Project: Topline Federal Credit Union

Location: 900 American Boulevard West: Bloomington

Reviewer(s): Gabby Campagnola and Louise Heffernan; Barr Engineering Co.

General Background & Comments

DESCRIPTION:
GRADING,
DRAINAGE AND
EROSION
CONTROL PLAN

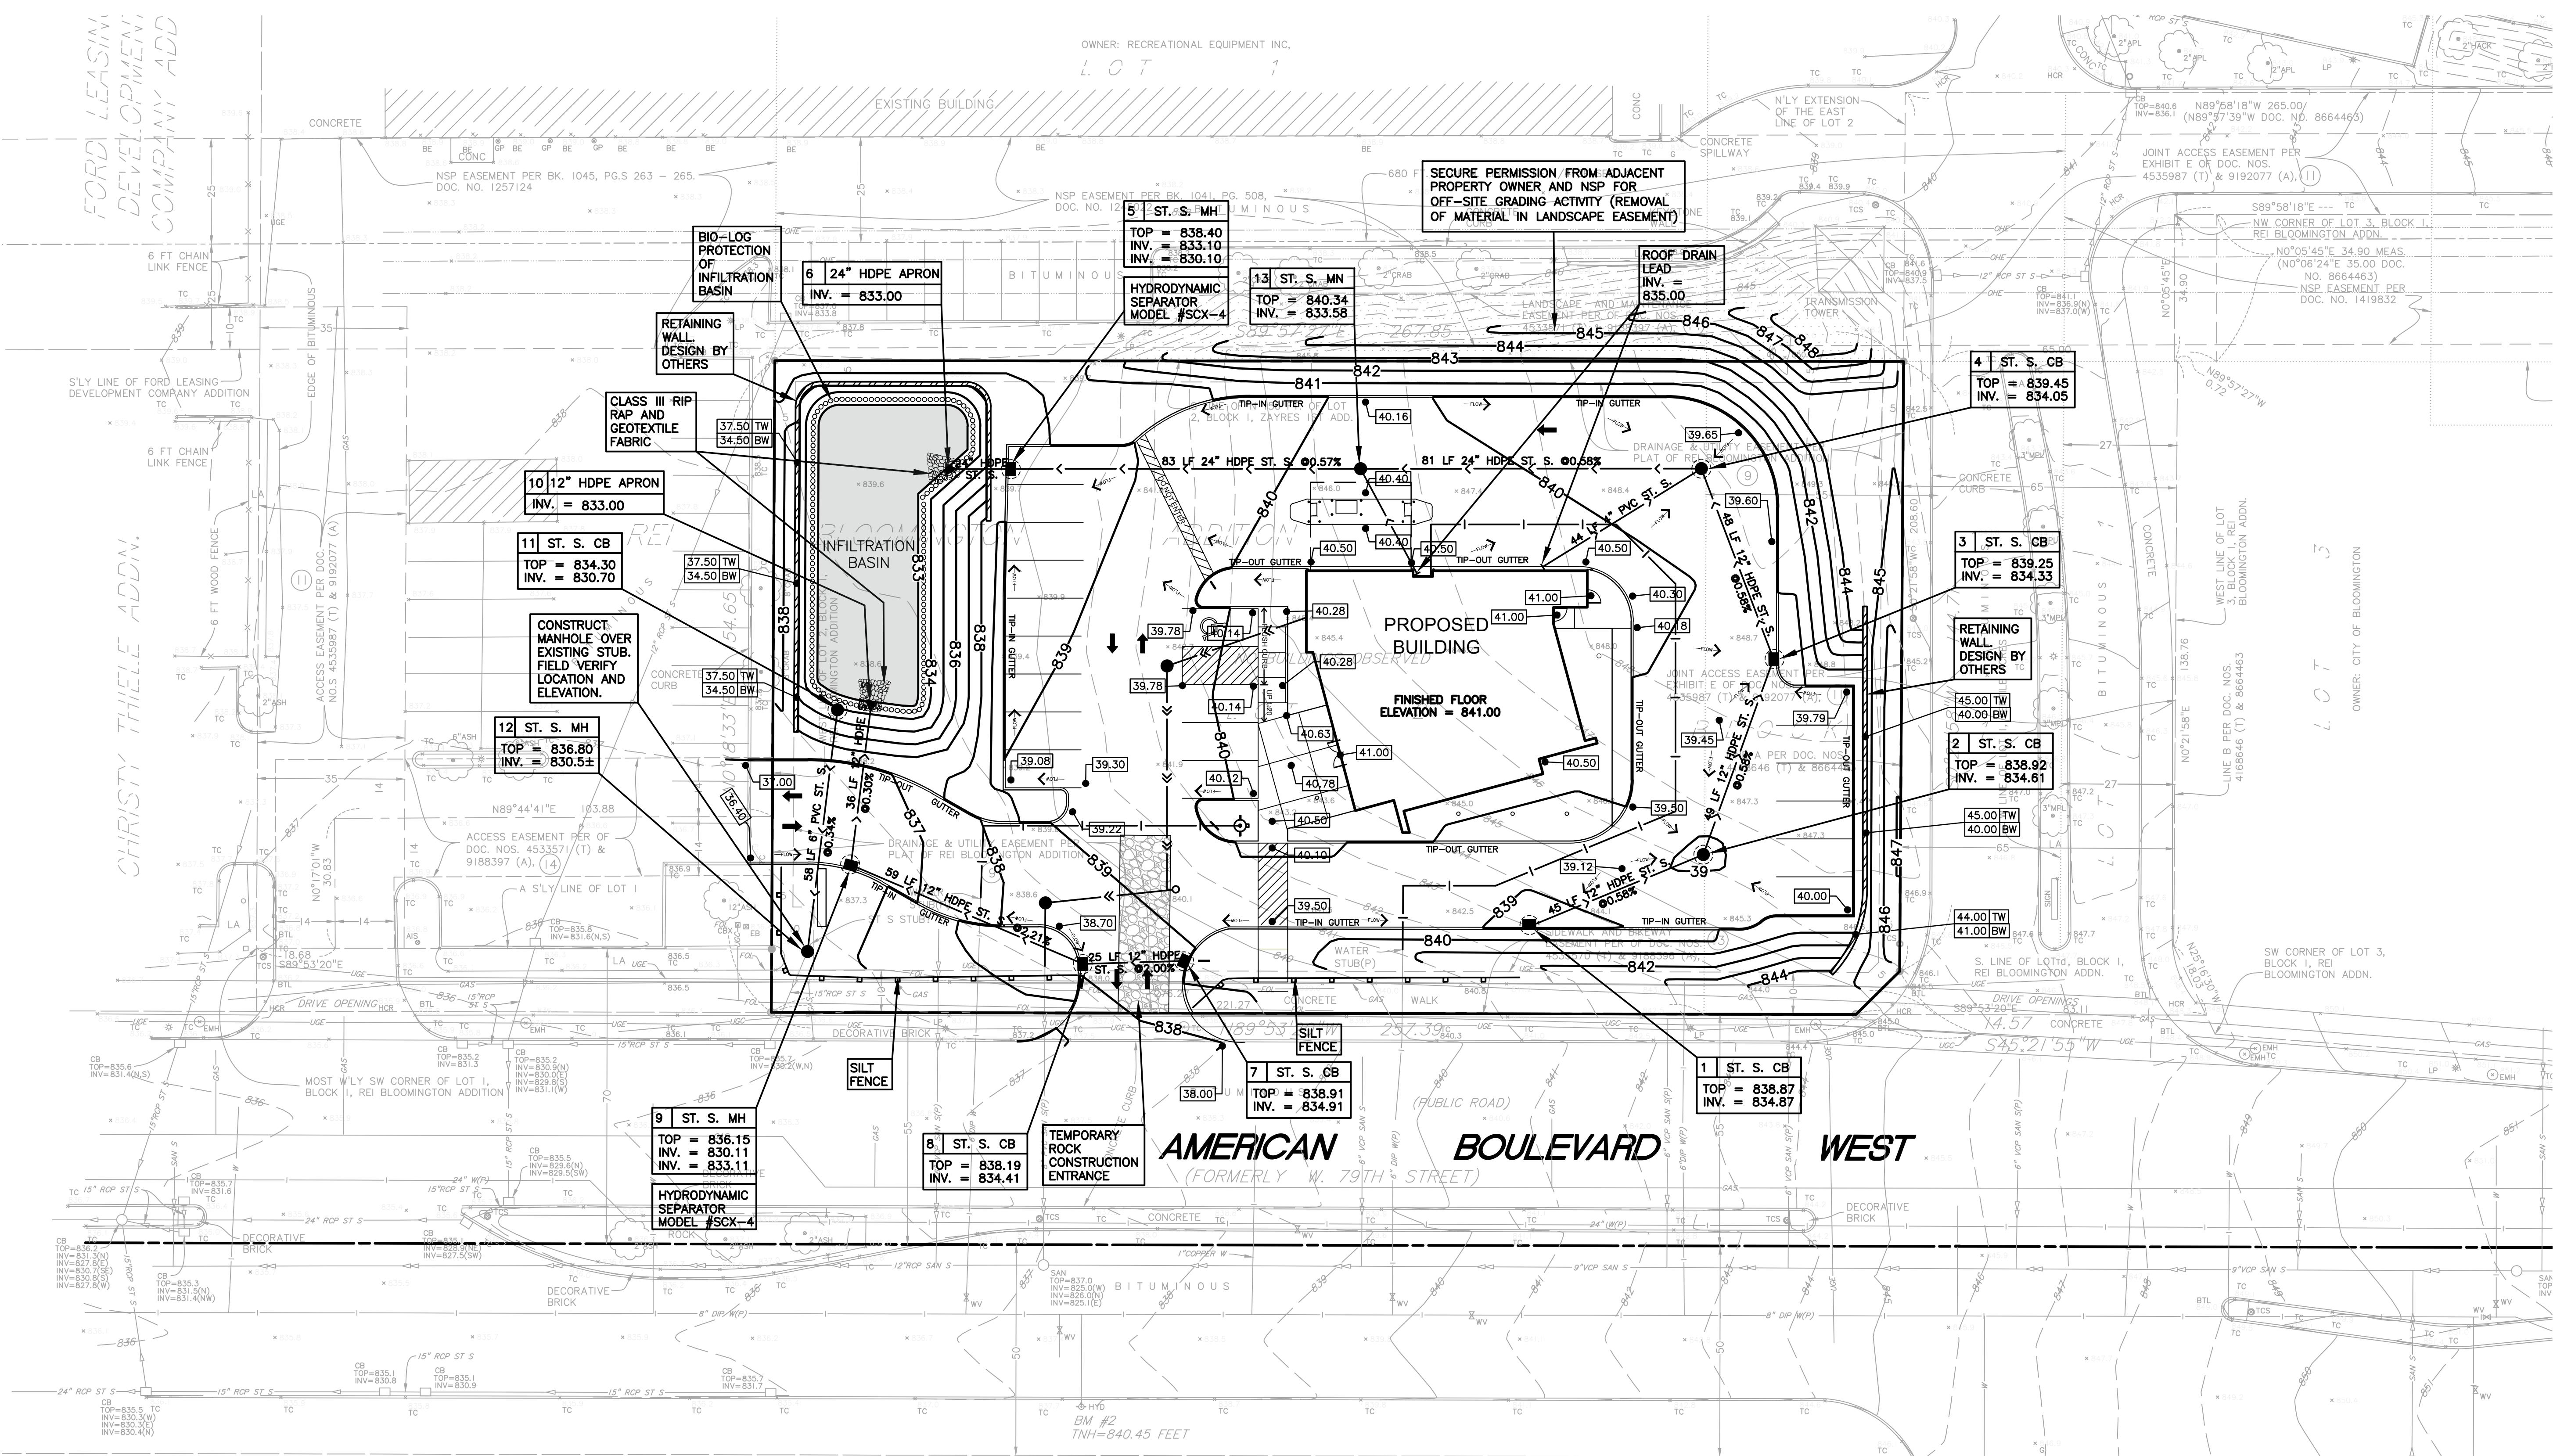
Rule 4.5.4d (i) requires at least three feet of separation between the bottom of an infiltration facility and groundwater. The Terracon Consultants, Inc. geotechnical evaluation indicates that groundwater was not encountered in any of the soil borings. Soil boring B-7 taken near the proposed Basin did not encounter groundwater to the bottom of the boring, elevation 824.5 +/- M.S.L. The following table provides a comparison of the bottom elevation of the Basin in relation to the elevation groundwater was not encountered.

Rule 4.3.3 states that all new and reconstructed buildings must be constructed such that the low floor is at least two feet above the 100-year high-water elevation or one foot above the emergency overflow of a constructed facility. Additionally, Rule 4.3.3 states that all new and reconstructed buildings must be constructed such that no opening where surface flow can enter the structure is less than two feet above the 100-year high-water elevation of an adjacent facility. Rule 4.3.3 also states that a stormwater management facility must be constructed at an elevation ensure no adjacent habitable building will be brought into noncompliance with a standard in subsection 4.3.3. The low floor and low opening elevations of the proposed building and existing building on adjacent property in relation to the Basin's 100-year high-water elevation is summarized in the table below.

The erosion control plan prepared by Sunde Engineering, PLLC. includes installation of silt fence, sediment control logs, a stabilized rock construction entrance and storm drain inlet protection.
